Moolarben Coal mine Complex (MCC) Modification 15 application seeks approval to locate and install 4 expanded dewatering sites above Underground No. 4 Mine (UG4). This would involve the drilling of a cluster of 3 de-watering boreholes (nominal diameter ~700mm) per site plus associated clearing for installation and access tracks in an existing biodiversity offset area.

Julia Imrie BSc. Grad Dip Water Res. Dip Ed.
PhD (conferred Dec'19)
Fenner School of Environment and Society, Australian National University

Figure 1: Location of MCC UG1 & UG2; monitoring bores PZ192, PZ193, PZ105, PZ103, PZ191 & PZ179 and proposed location of dewatering bore sites (MOD 15)

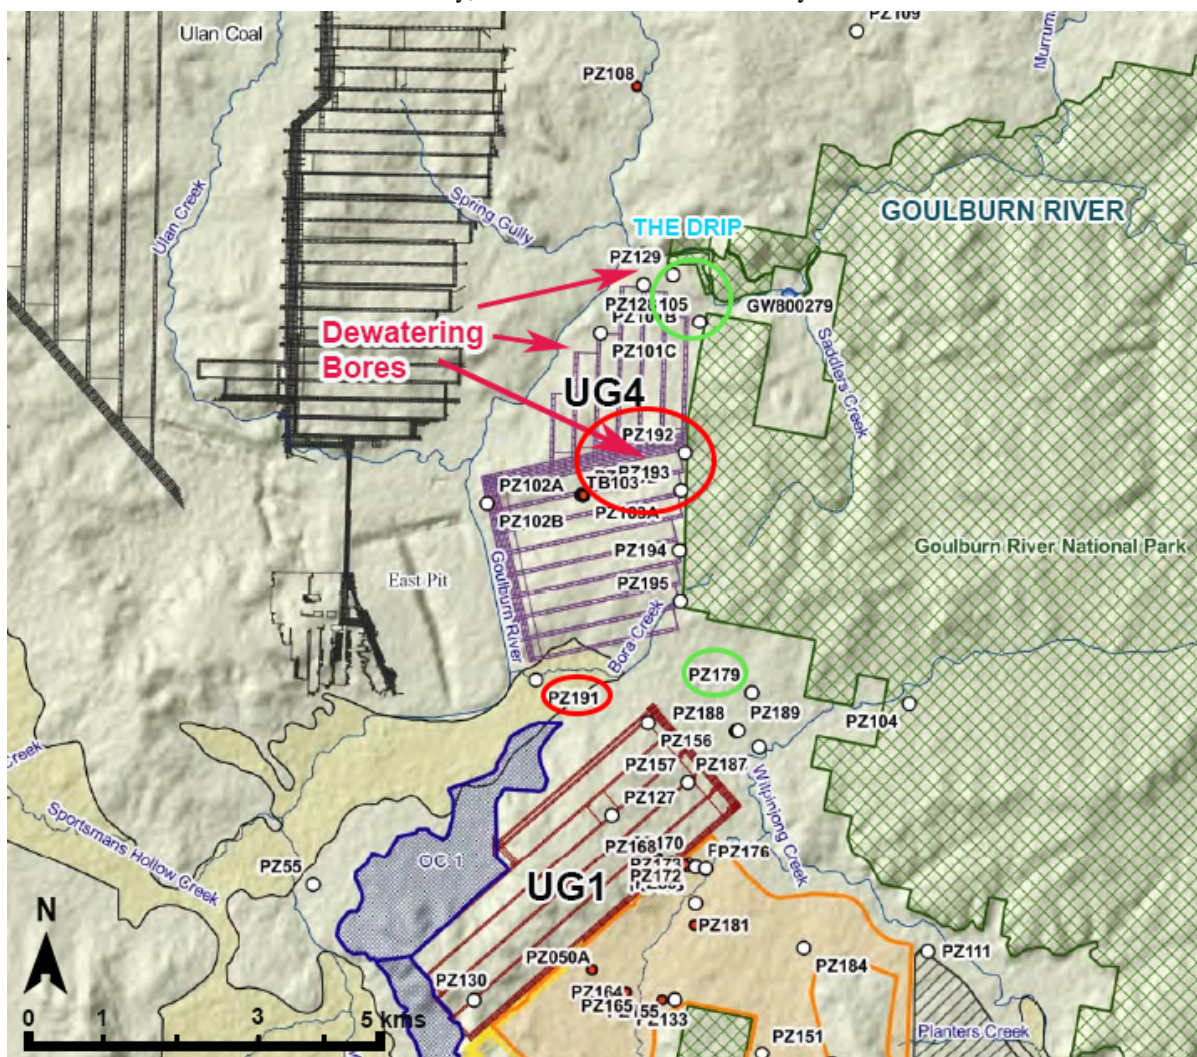
The location of the northern bore sites - opposite The Drip GDE¹, and approximately 250 metres from the Goulburn River is of major concern considering the close proximity to significant natural features, cultural sites and the potential interception and depressurisation of the Triassic/upper Permian groundwater system. Construction of the northern dewatering sites is predicted to occur approximately 3 years after the southern sites - in or around the year 2026.

MCC has frequently reported that groundwater within the UG4 footprint is low quality and of limited value. The salinity and pH of groundwater monitored at PZ103 and PZ105 located within the UG4 (Figure 1) demonstrates the presence of high quality, potable water sources in all three water bearing strata - the median range of salinity EC levels 235 - 580 $\mu\text{S}/\text{cm}$, with a potential yield in excess of 4L/s (Table 1). The characteristics of these groundwater sources should trigger the Aquifer Interference Policy (NSW Office Of Water, 2012). There is also evidence based on hydrochemical characteristics and behaviour of the SWLs in response to mining of some connectivity between the water bearing strata (see Piper plot - Figure 5). Groundwater rainfall recharge is most likely occurring along the alluvial drainage basin marked by tea-tree riparian heathland (Hill, 2000) in the eastern and northern areas of UG4.

Please note MCC UG4 dewatering bore sites are located within 250 metres of the Goulburn River and longwall panels 500 metres from The Drip and Corner gorge (see Figure 1). If a similar outcome is experienced in UG4, the groundwater depressurisation and drawdown of water bearing strata would extend well under both the Goulburn River and The Drip GDE.

Figure 2: Decline in upper groundwater levels (mAHd) in monitoring bores PZ179, located ~ 2 kms NE of MCCs UG1 mine Jan'16- Feb'19 following development of UG1 in late 2016 despite significant rainfall June-Sept 2016.

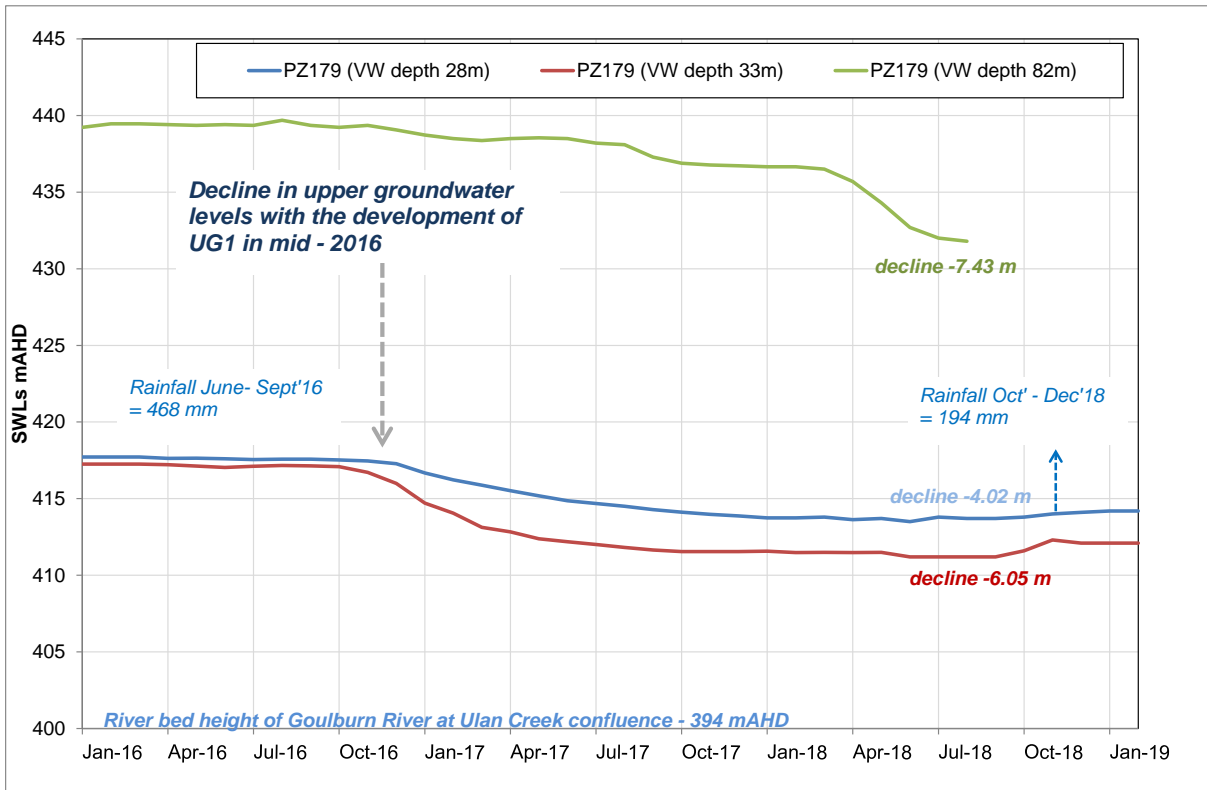
There has been a more than 6 fold increase in actual mine water-make (1 ML/day to > 6.8 ML/day) compared to the earlier predictions of groundwater inflows (Middlemis and Fulton, 2011) (HydroSimulations, 2017). The source of this extra inflows has not been adequately investigated but in my professional opinion is from the interception of additional groundwater sources above the coal seam - from Triassic and upper Permian water bearing strata. This is supported by groundwater monitoring (since 2016) which show a significant decline in standing water levels in all water bearing strata at a number of monitoring sites 2-4 kms from UG1 (above UG4 PZ179, PZ191, 192 and PZ193 - Figure 1). Figures 2 and Figure 3 show the decline in upper groundwater levels (mAHD) in monitoring bores PZ179, located ~ 2 kms NE of Moolarben CC UG1 mine and PZ192, PZ193 located >4 kms from UG1, between January 2016 and February 2019 following development of UG1 in late 2016.

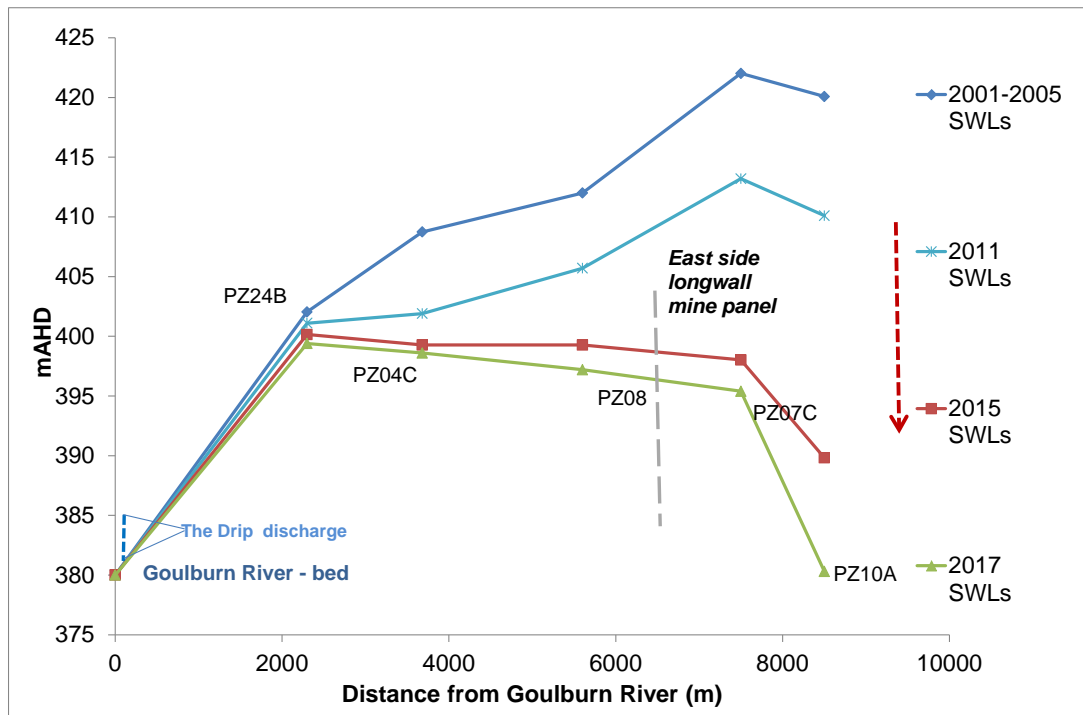
The potential extent of depressurisation resulting from UG4 may be extrapolated from the measured decline in Triassic groundwater levels experienced at Ulan Coal Mine between 2001 and 2017 (shown in Figure 4). This graph demonstrates the extent, as a function of distance, of groundwater drawdown due to mine depressurisation. There is around a 15 metre decline in groundwater levels, 500 meters from Ulan Coal longwall mine No. 3.
